Common Council Chambers – City Hall Room 100
7325 W. Forest Home Ave., Greenfield, Wisconsin

PLAN COMMISSION STAFF REPORT

Tuesday, February 13, 2024 – 6:00 p.m.

Conceptual Site Plan

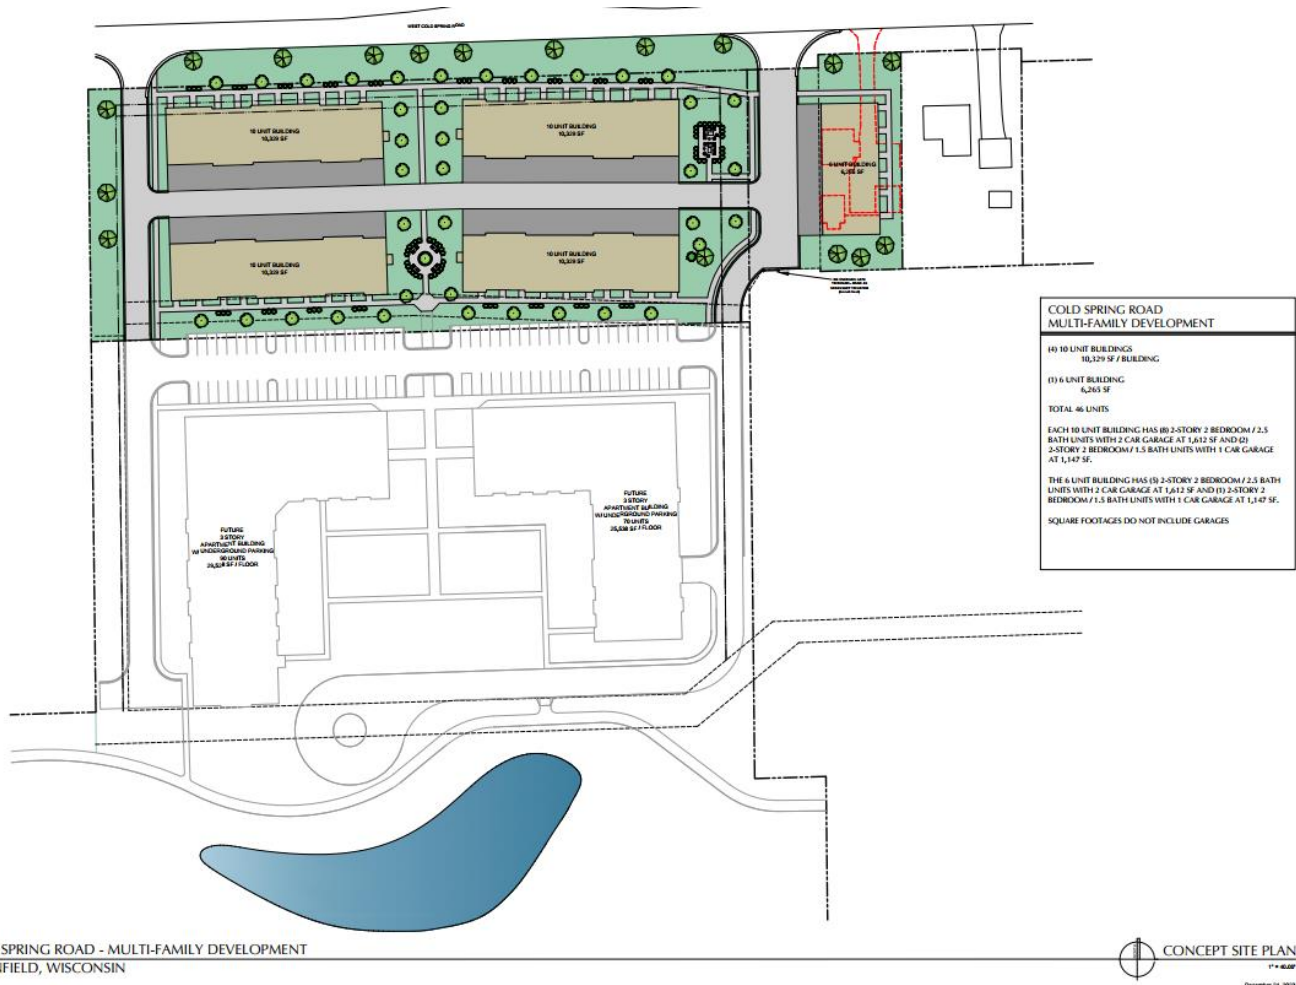
The PUD standard table above indicates that after all phases are constructed, there will be 338 parking spaces provided and 422 required per Code, a shortage of 84 parking spaces.

The developers also own the single-family-zoned parcel to the east of the We Energies driveway, at 9531 W. Cold Spring Rd. That parcel is where the 6-unit townhome is depicted on the conceptual site plan. There are a few issues with this proposal that would need to be rectified, in order to move forward with this concept:

- The parcel is zoned R-2 Single-Family Residential Conservation District, so it cannot have a stand-alone 6-unit townhouse built on it, as is proposed.
- The parcel can't be rezoned PUD because the city has a 5-acre minimum requirement for the PUD zoning district.
- Staff suggests swapping land with We Energies and building the townhouse where the current We Energies driveway is, and moving the driveway east to 9531 W. Cold Spring Rd., then doing a CSM for land maneuvering, and then the new land that's added to the larger 20.15-acre parcel, can be rezoned to PUD.
- This seems to be the only feasible way for the development to include the 5th townhouse.
- The developer will need to coordinate the land swap before final site, landscaping and architectural plans can be considered.

Staff has the following initial comments/questions on the site plan layout:

- Protect/maintain the existing tree line along the west property line that abuts the back yards of the residential properties along S. 99 St. and the side yard of 9803 W. Cold Spring Rd.
- Try to accommodate more visitor parking closer to the northern townhomes. Likely need more visitor parking than what's proposed at this time. All surface parking should be constructed with Phase 1.
- Garbage details are needed—unsure if there will be one (1) or a couple central, larger refuse enclosure areas? Or are the townhomes using rolling carts that will be kept in the garages?
- Where will the central mailbox area be located?
- Move the grill area to a more centralized area.
- Move the sidewalk that's parallel to W. Cold Spring Rd., within the ROW, or construct a second sidewalk in the ROW.

Conceptual Architectural Plans

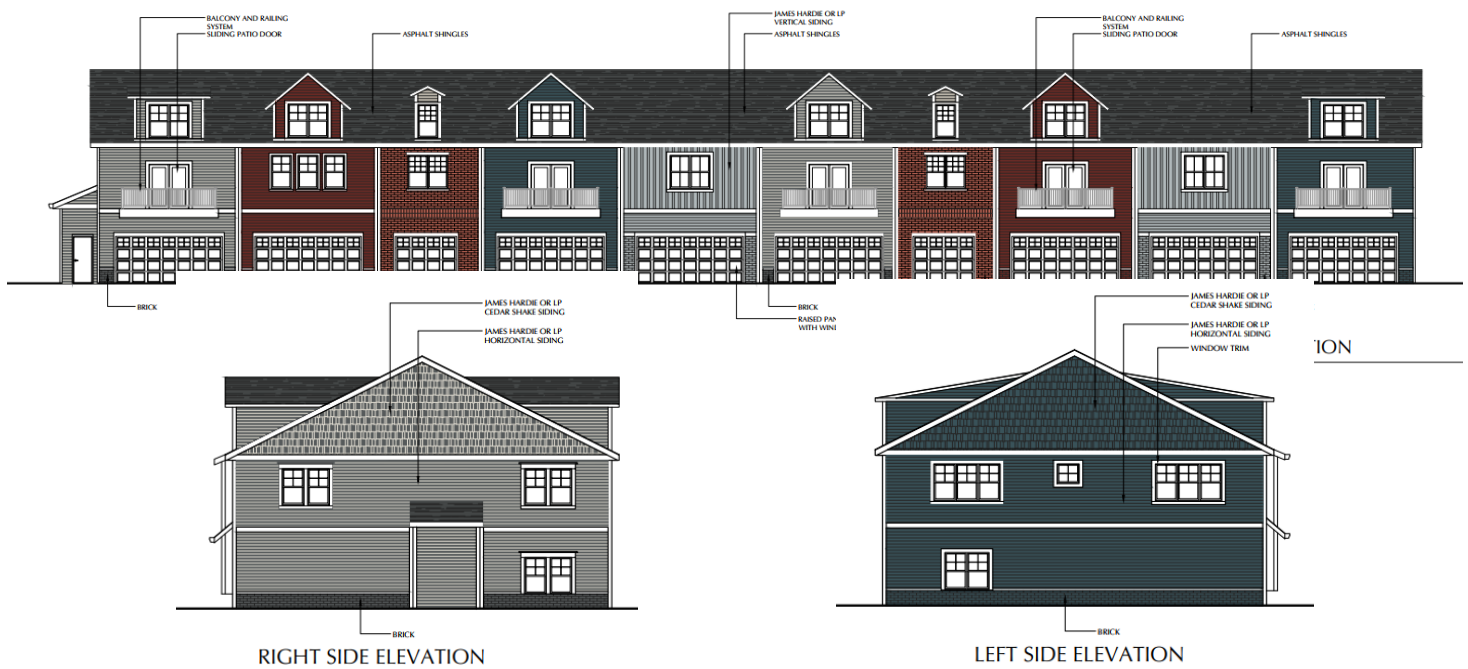
Building materials include James Hardie or LP siding (vertical, horizontal and shake), and brick. At a bare minimum, each unit has a brick base. Some units are brick from bottom to top. If the style holds for final design, staff is recommending that the brick bases be raised higher. Staff is also recommending that a wood-grain-like garage door be used, rather than white panels. The garage doors do include windows. The plans show asphalt shingles. A material board would be requested at the time of submittal for final design.

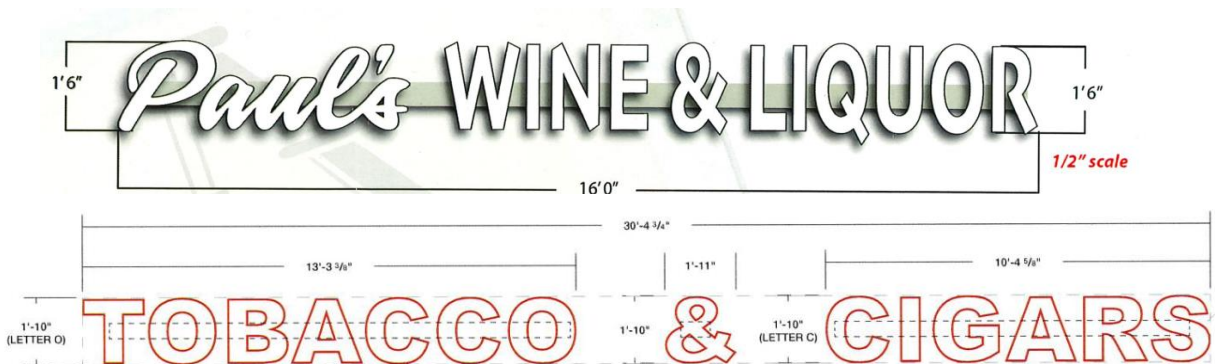
The application notes that the "proposed letter set will compliment the neighboring business' letters, Paul's Wine & Liquor which are white lexan faces". However, the compliment only applies to the coloration of the signs. The proposed "TOBACCO & CIGARS" sign has a different font, kerning (spacing between letters and symbols), and size (letter height) than the existing "Paul's WINE & LIQUOR" wall sign.

Staff recommends approval of the signage waiver for the additional wall sign but denial for the square footage of signage beyond what is permitted by code.

The current proposal results in unmatched signage between businesses that share a parking lot and similar architectural styles. Having a unified font used by both businesses would create a sense of coherence, visually contributing to a more professional, intentional, and aesthetically pleasing outcome. While staff recommends denial of waiver for square footage, as submitted, staff would recommend approval for square footage beyond what is permitted by code if the proposed “TOBACCO & CIGARS” sign was amended to match the existing “Paul’s WINE & LIQUOR” sign in size (height), font, and kerning.

If the square footage waiver was denied, Vape City Tobacco would still have 34.5 sq. ft. of signage permitted for their third wall sign. A sign of this size would be nearly 50% larger than the present “Paul’s WINE & LIQUOR” sign. In this scenario, Vape City Tobacco can maintain the proposed font and kerning and would only need to adjust the sizing.
